1CAN090401

September 30, 2004

SUBJECT: License Amendment Request
Proposed Technical Specification Change for Revision to ANO-1 Steam
Generator Tube Inservice Inspection Program
Arkansas Nuclear One, Unit 1
Docket No. 50-313
License No. DPR-51

FIGURE 5.5.9-1

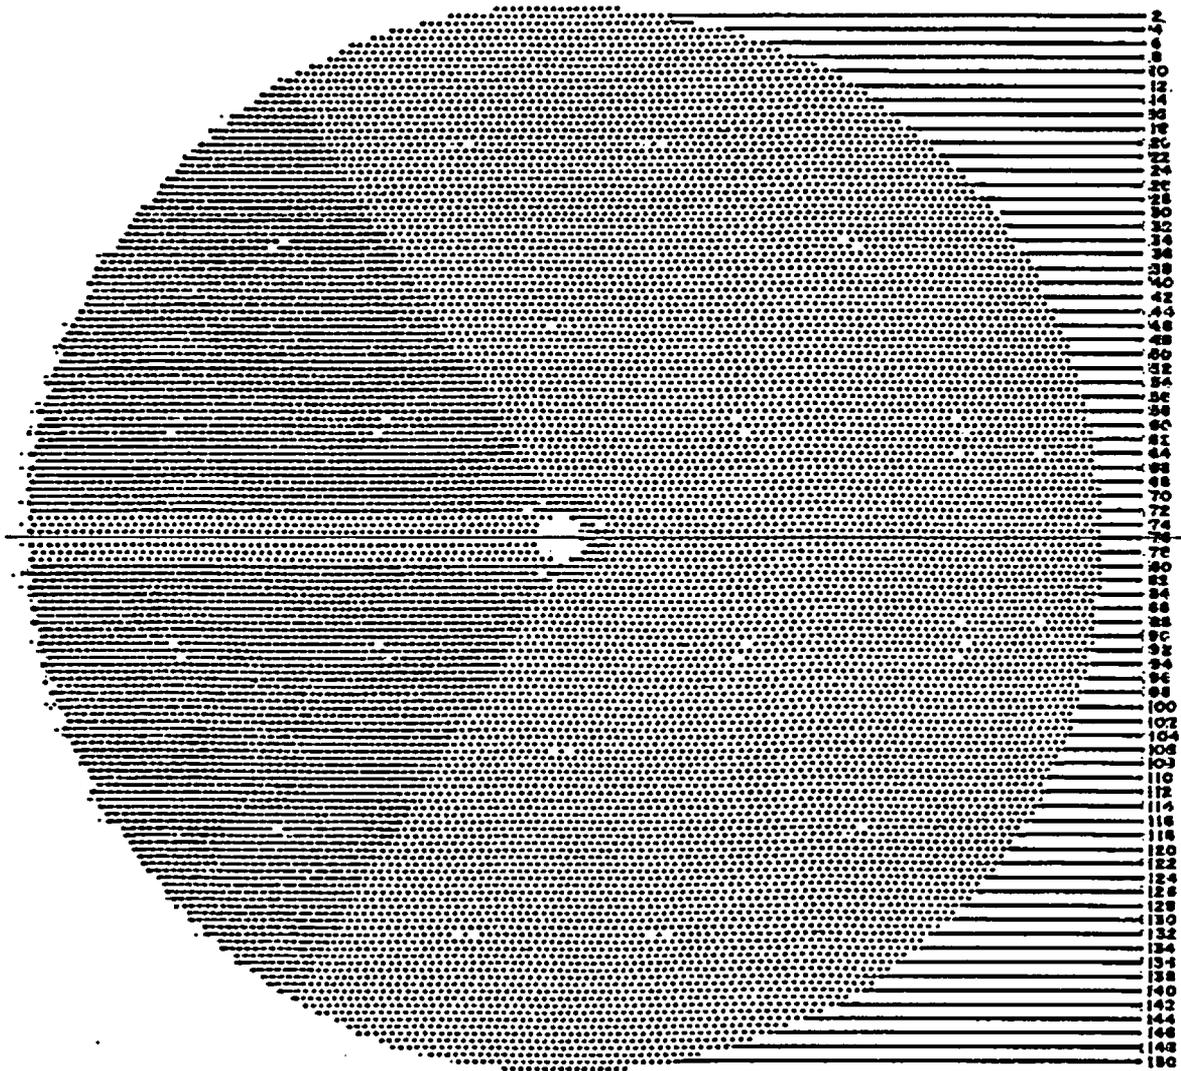
- (1)—~~Group A-1: Tubes within one, two or three rows of the open inspection lane.~~
- (2)—~~Group A-2: Unplugged tubes with sleeves installed.~~
- (3)—~~Group A-3: Tubes in the wedge-shaped group on either side of the lane region (Group A-1) as defined by Figure 5.5.9-1.~~
